RESOLUTION NO. 2016-172

A RESOLUTION OF THE CITY COMMISSION OF CORAL GABLES, FLORIDA REQUESTING MIXED-USE SITE PLAN REVIEW PURSUANT TO ZONING CODE ARTICLE 4, "ZONING DISTRICTS," DIVISION 2, "OVERLAY AND SPECIAL PURPOSE DISTRICTS," SECTION 4-201, "MIXED USE DISTRICT (MXD)," FOR THE PROPOSED PROJECT REFERRED TO AS "GABLES STATION" ON THE PROPERTY LEGALLY DESCRIBED AS TRACTS A AND B, BLOCK 5, AND TRACT 1, MACFARLANE HOMESTEAD AND ST. ALBANS PARK (215 AND 251 SOUTH DIXIE HIGHWAY), CORAL GABLES, FLORIDA; INCLUDING REQUIRED CONDITIONS; PROVIDING FOR A REPEALER PROVISION, PROVIDING FOR A SEVERABILITY CLAUSE, AND PROVIDING FOR AN EFFECTIVE DATE. (LEGAL DESCRIPTION ON FILE AT THE CITY)

Gables Station

215 AND 251 S. DIXIE HIGHWAY
CITY COMMISSION 2ND READING
JULY 26, 2016

#1: BUILDING HEIGHT

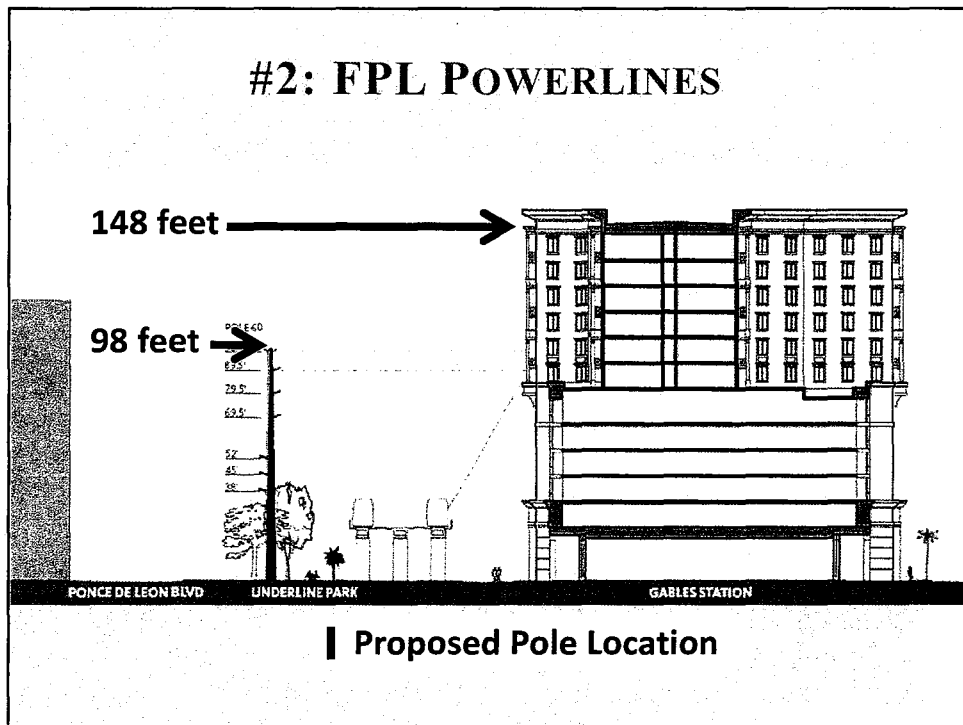
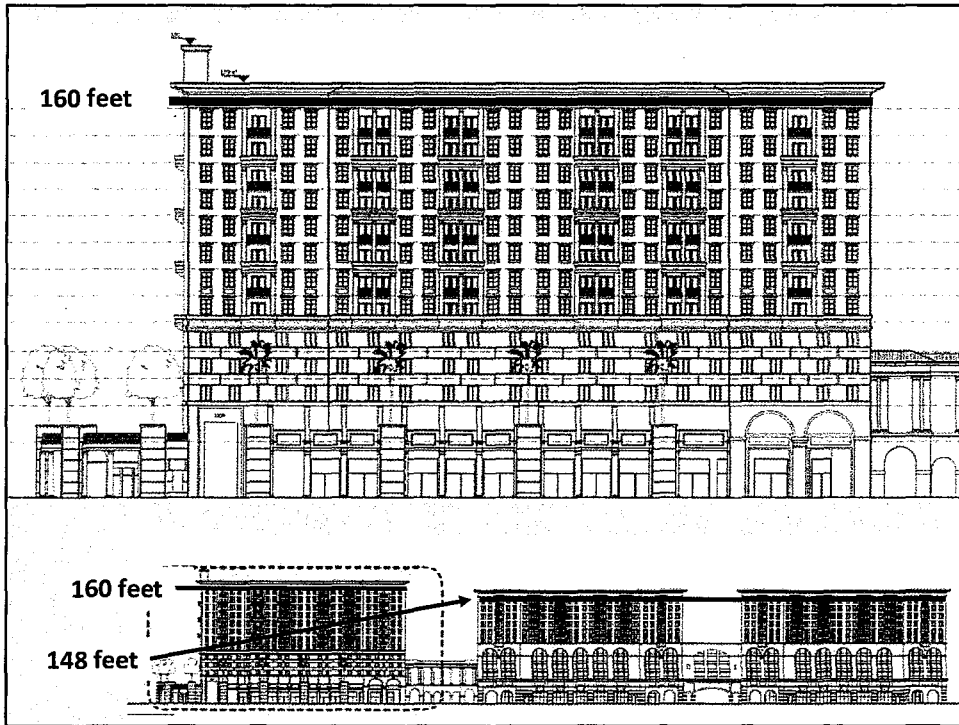
1. Reduce building height while maintaining the same percentage of open space.
2. Show FPL powerline locations in drawings of the Underline.
3. Finalize the trolley contribution proposal.
4. Confirm the timing of the Underline improvements.
5. Update the Traffic Impact Study.
6. Provide the Art in Public Places concept.
7. Update site plan to include more landscaping at the ground level.

Due to the specific site characteristics of this Mixed-Use redevelopment site adjacent to Metrorail and its associated noise and visual impacts, **Staff recommends approval of the project at the height proposed by the Applicant: 160 feet for Building A and 148 feet for Buildings B and C.** The proposed height is less than the maximum height allowed in the City (190'6").
